## Highways Technical Note

### Response to Highways Comments from Cumberland Council

**Demolition Of Existing Buildings And Erection Of A Discount Food Store, Alterations To Vehicular And Pedestrian Access, Provision Of Car And Cycle Parking, Servicing Area, Hard And Soft Landscaping And Associated Works - Land At East Road, Egremont**

CC Reference Number - 4/24/2044/0F1

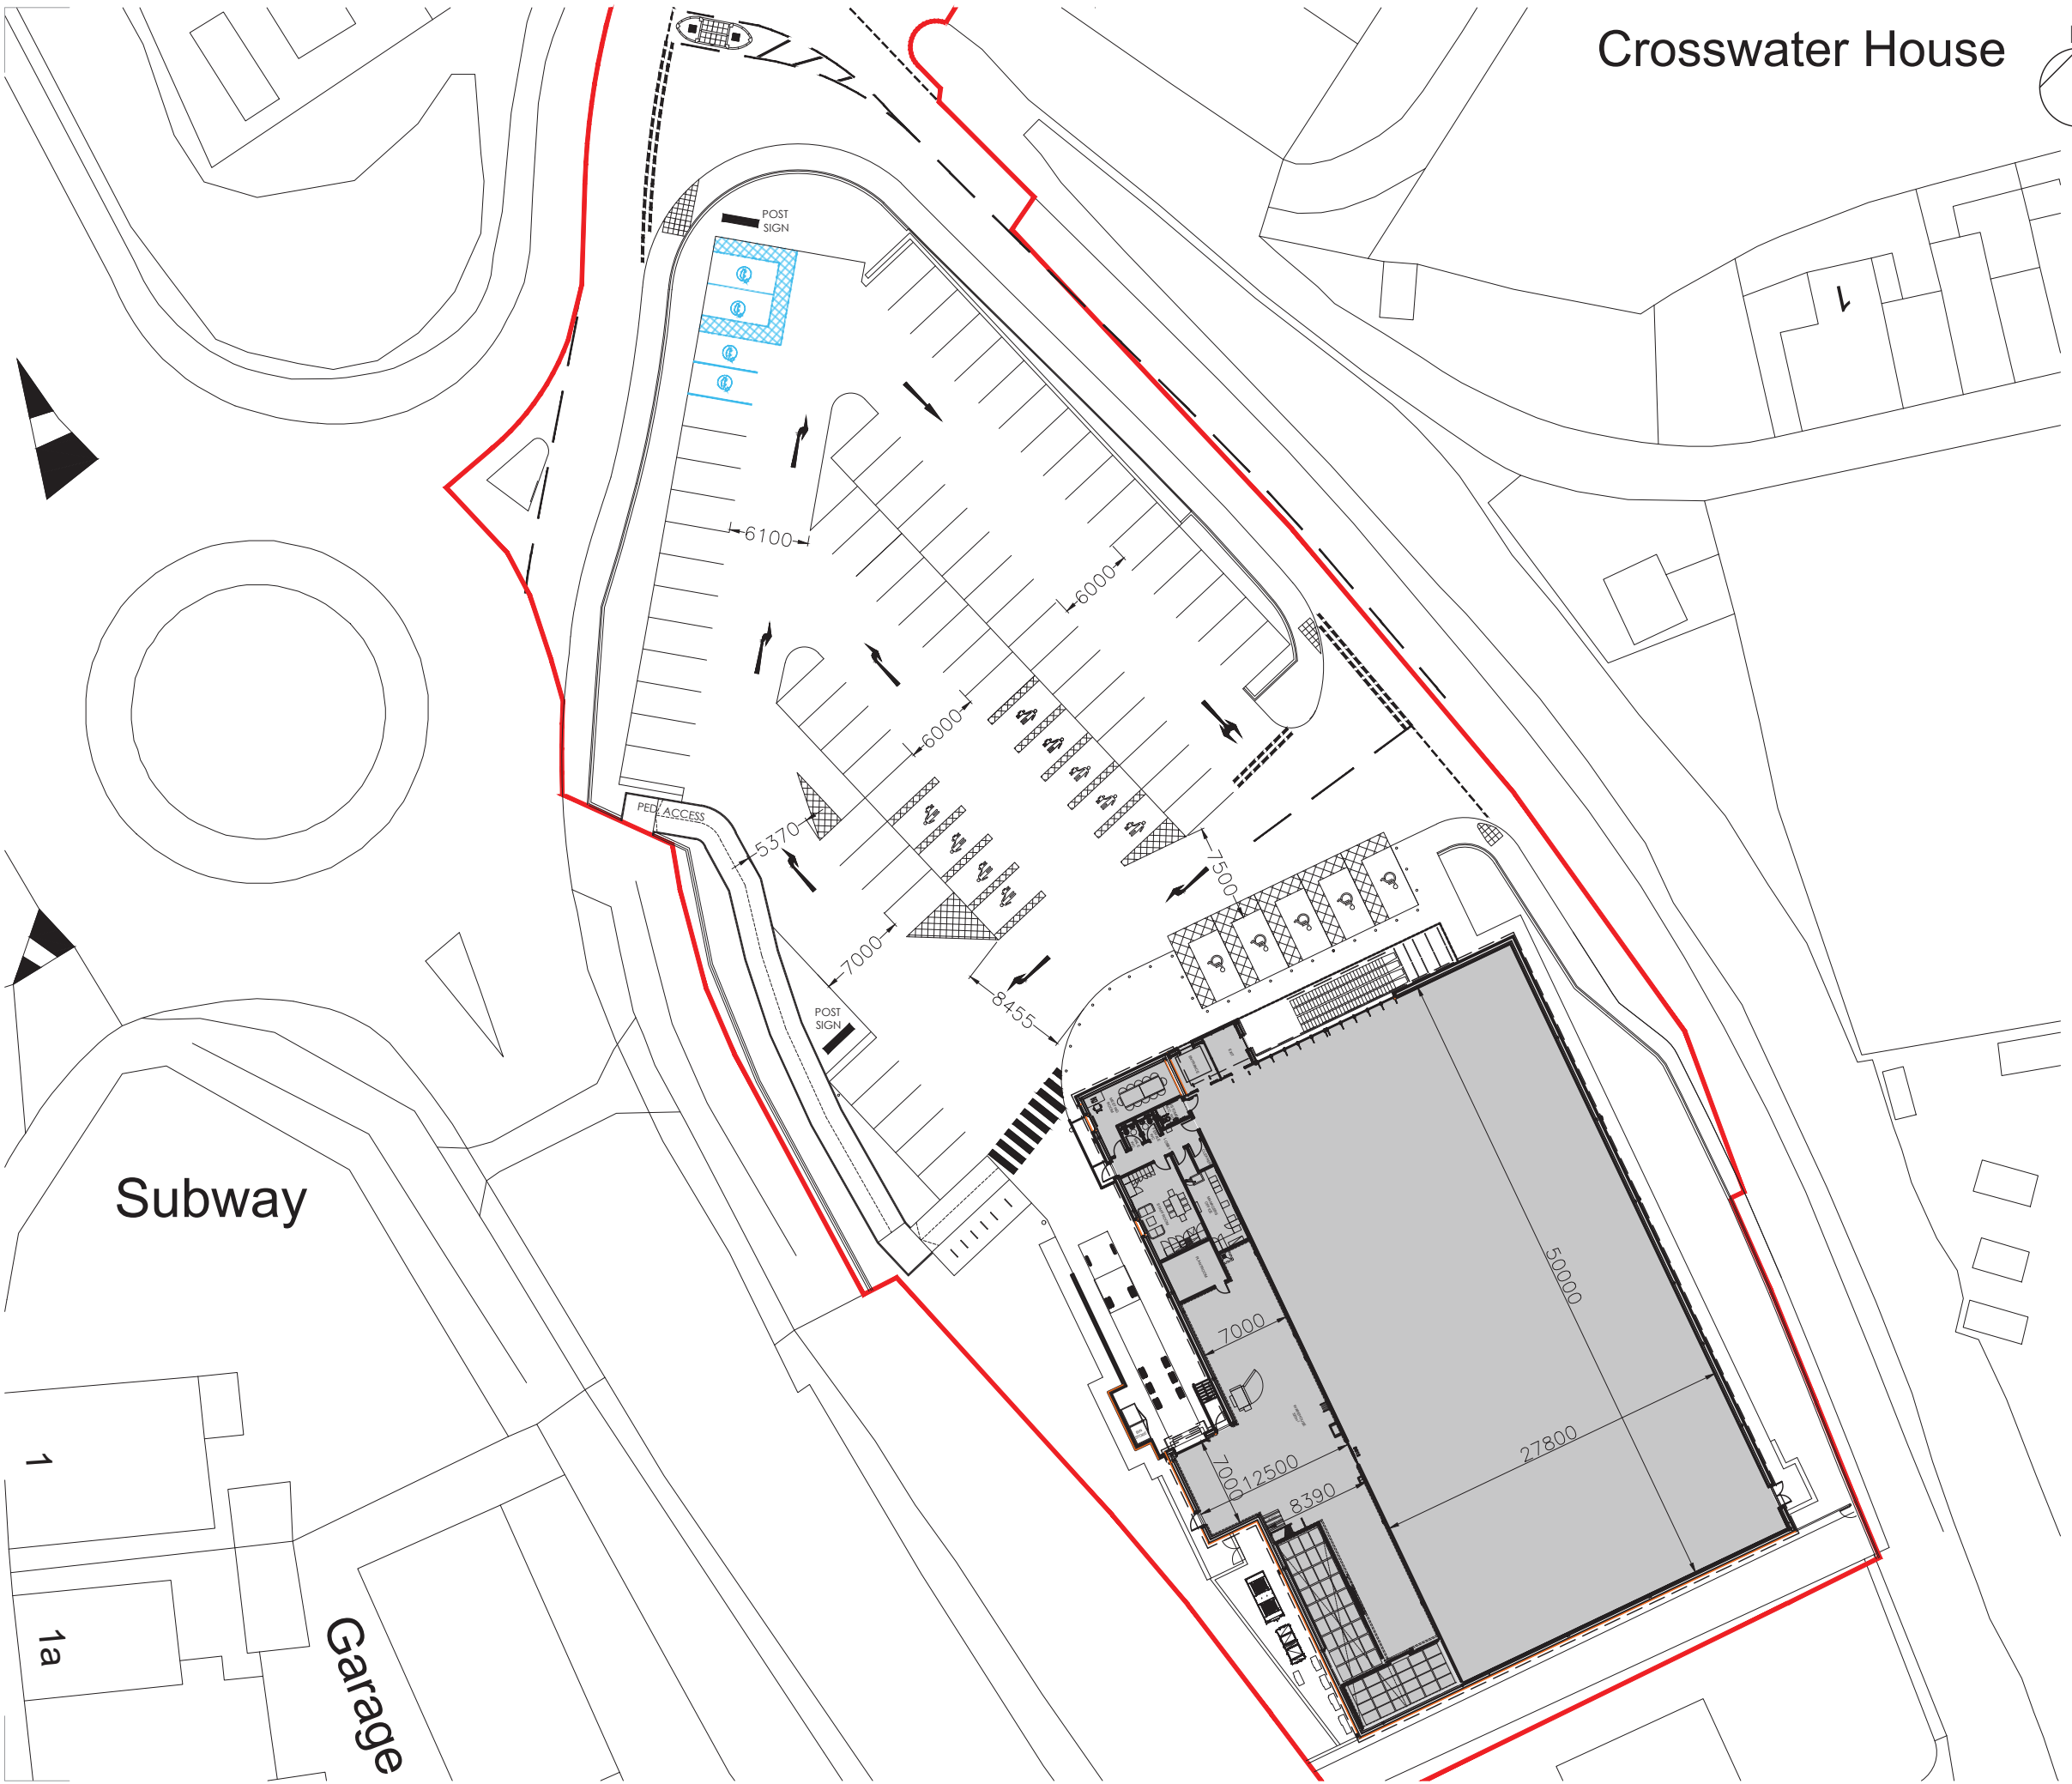
*I note that there is a link to the underpass ('ped access' on the plans). This is welcomed but should be 3m wide not 2m wide to better accommodate cycles, pushchairs and wheelchairs etc. Also, since the footway is next to parking bays, the overhang from cars will effectively reduce the usable footway width. This path must be step-free and a maximum gradient of 1:10. Instead of coming off the top or the ramp at footway level, the applicant should consider the potential of routing a path from the underpass at a lower level, straight into the car park near to the cycle stands. This would be a more direct route and almost at the same level so would be easier and quicker to use. I note that the applicant is having discussions with National Highways and I look forward to some progress.*

*In the meantime, the fall-back provision of a stepped access is not acceptable to the LHA. This should be a ramp as described above (3m wide) and as such revised details will need to be submitted for approval.*

The new path which connects the application site to the existing footway adjacent to the roundabout is provided at a gradient of 1:30m and has been re-designed to be step-free. A copy of the updated Site Layout is attached to this HNT at **Appendix C**.

The path has been designed to a width of 2.5m, this is the maximum width which can be provided without encroaching onto the internal layout and resulting in the loss of parking bays. For reference, a width of 3m would result in the loss of 3 parking bays which in turn would equate to a total parking area of 83bays.

In the balance of the wider scheme, the proposed 2.5m width is considered to provide an appropriate width to accommodate both pedestrians with a buggy and cyclists. To ensure a safe environment for all non-motorised users (NMUs) accessing the private path, a 'cyclist dismount' sign will be provided to ensure that cyclists walk their bicycles down the ramp.

- Longstay cycle parking for staff has now been provided within the internal storage area, this can provide storage for a total of four bicycles. Details of this location are provided in the updated site layout plan. This storage arrangement is provided across other Aldi stores and is therefore considered an appropriate and safe provision for staff to store their bicycles;

- An adaptive cycle space is now provided as part of the updated site layout plan, this is provided to the north of the five Sheffield stands. The hoop serves two cycle spaces and provides a larger space to either side to accommodate adaptive cycles;
